## MC68341

# ADDENDUM TO MC68341 Integrated Processor User's Manual

April 19, 1995

**Figure 3-12. M68300 Write Cycle timing**

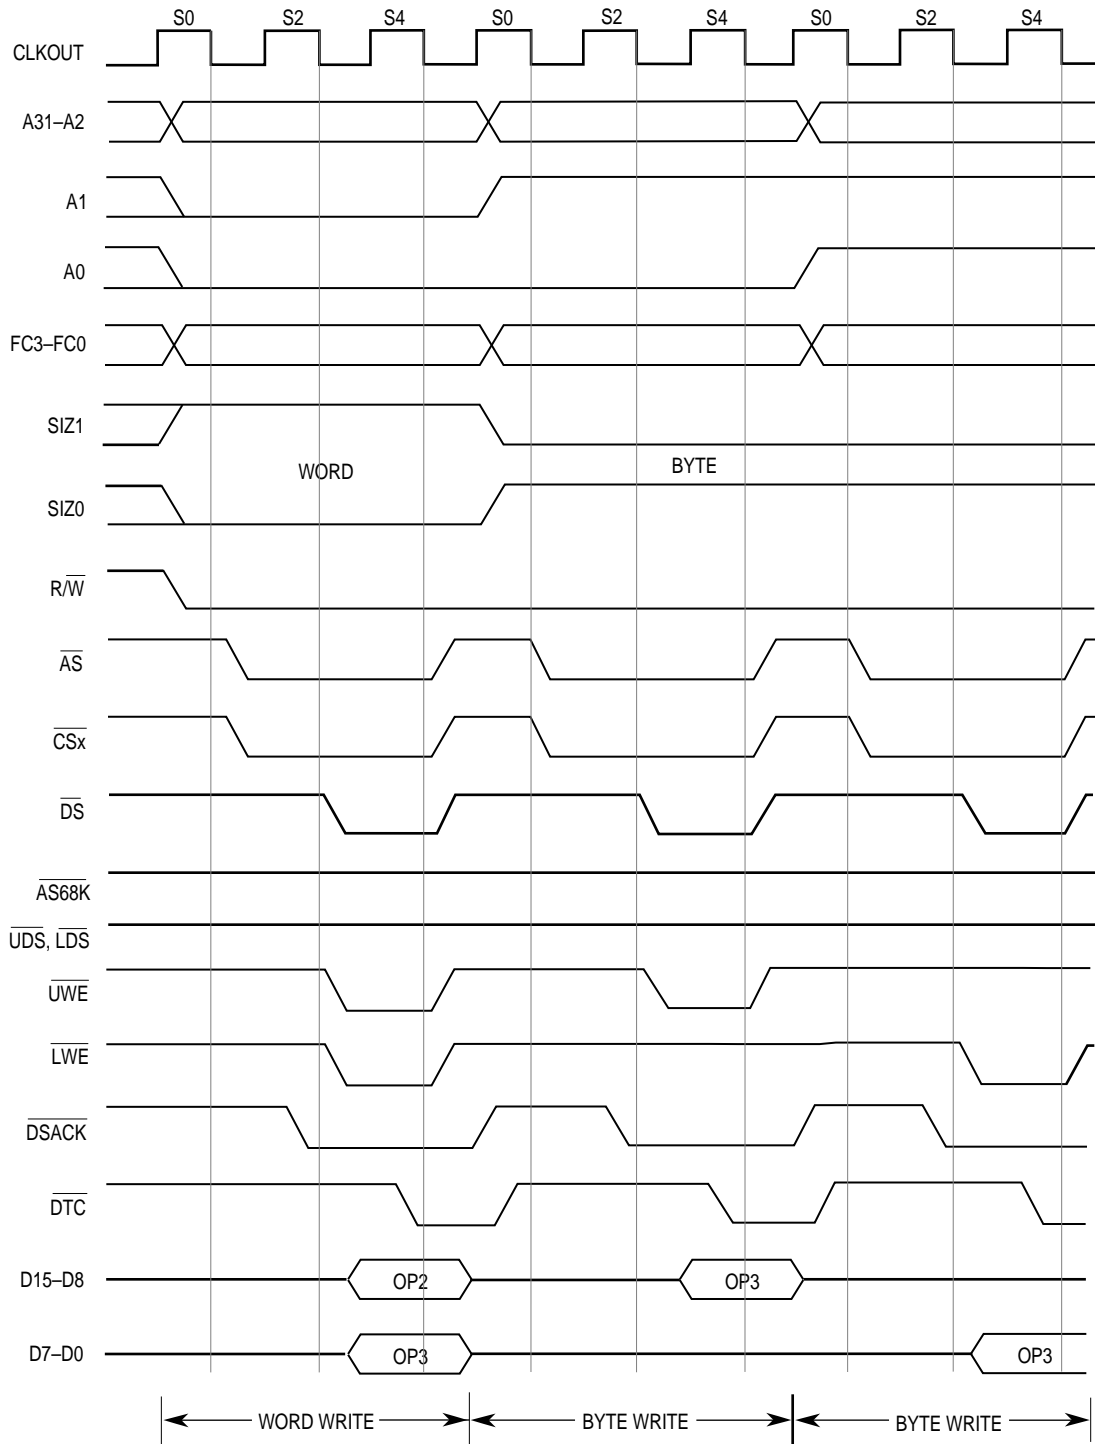
On page 3-25, the M68300 write cycle timing diagram (Figure 3-12) shows incorrect timing for  $\overline{DS}$ ,  $\overline{UWE}$ , and  $\overline{LWE}$ . On page 3-28, the M68000 write cycle timing diagram (Figure 3-14) shows incorrect timing for  $\overline{AS68K}$ ,  $\overline{CSx}$ ,  $\overline{UDS/LDS}$ , and  $\overline{UWE/LWE}$ . Replace these figures with the following corrected figures.

Figure 11-2. Sample Crystal Circuit

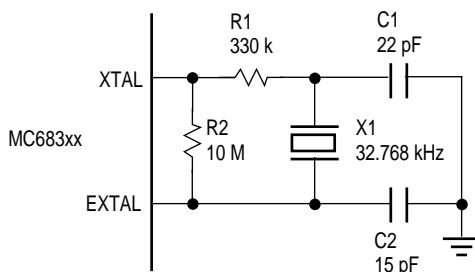
On page 11-2, Figure 11-2, a 10M resistor can be substituted for the 20M R2 bias resistor as shown below.

**Figure 11-14. Circuit For Interfacing 8-Bit Device to 16-Bit Memory in Single-Address DMA Mode**

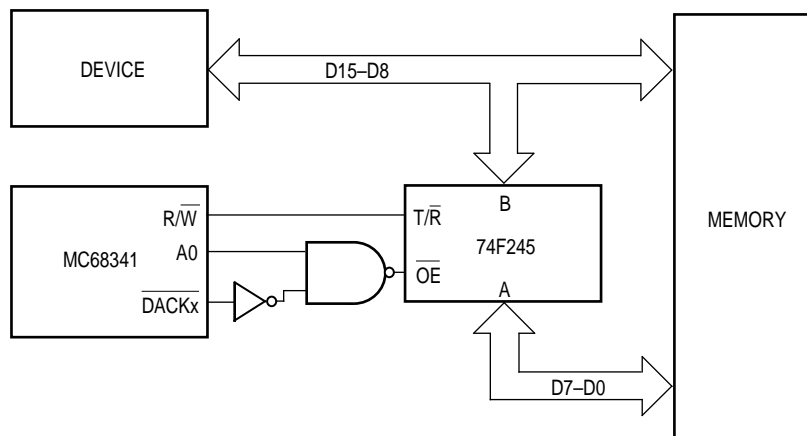
On page 11-10, the logic driving  $\overline{OE}$  on the 74F245 in Figure 11-14 should be corrected as shown below. Although not detailed, the byte enables for the memory block should be controlled during reads to prevent contention between the upper and lower bytes of the data bus when D7-D0 is muxed to the upper data byte.

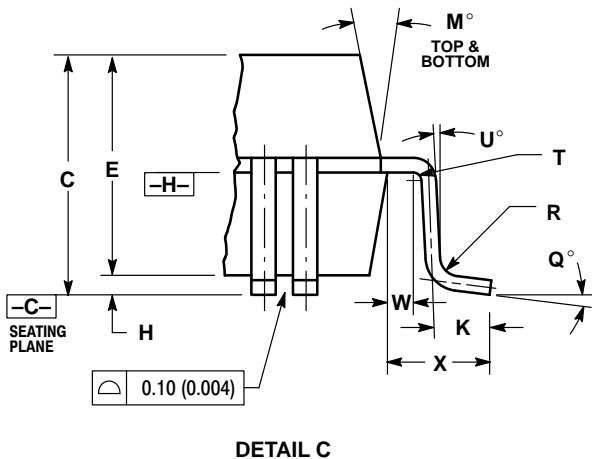
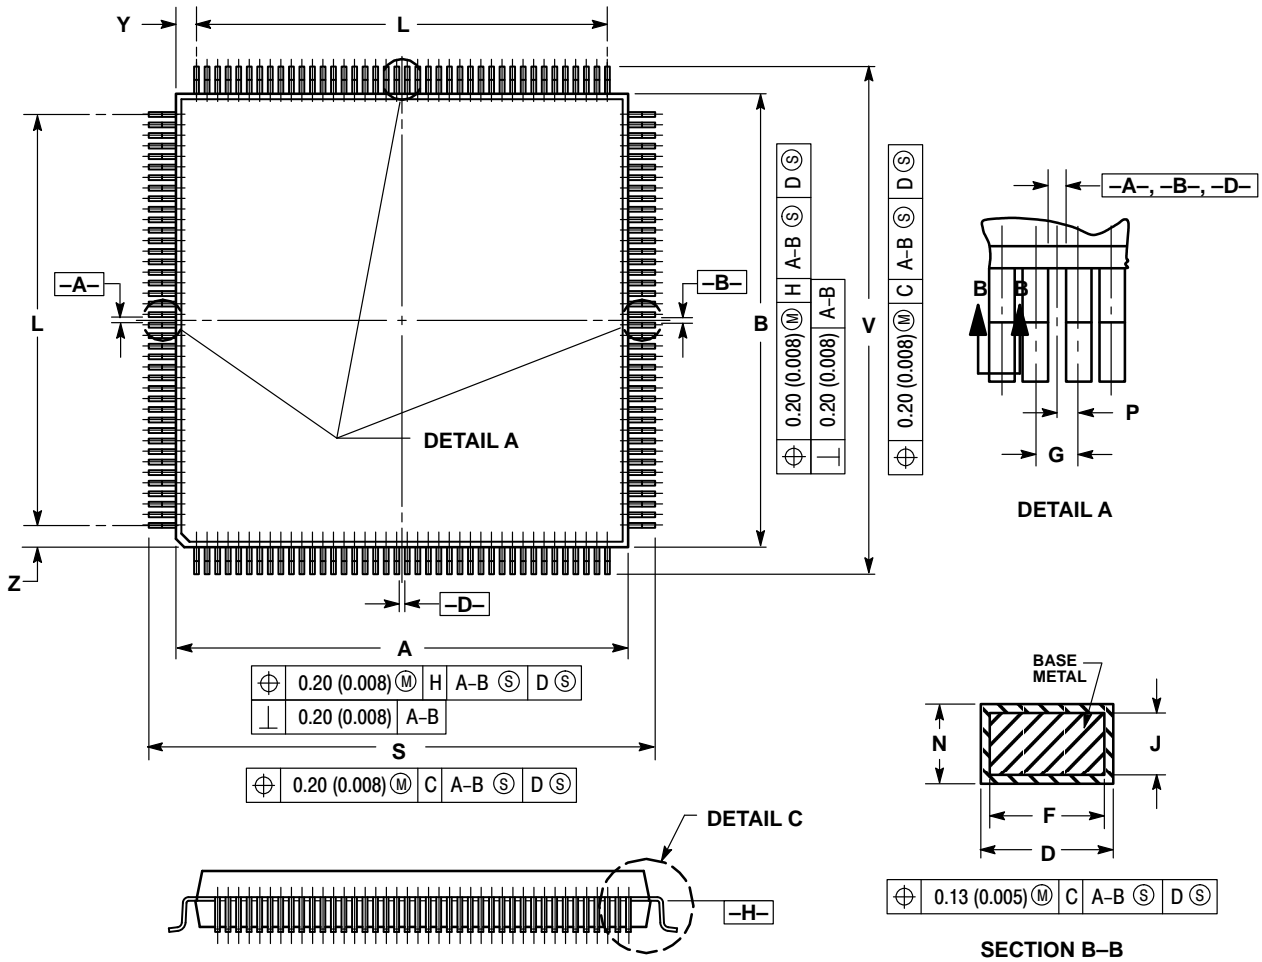
The package dimension drawing on page 13-3 should be discarded and replaced with the following drawing.
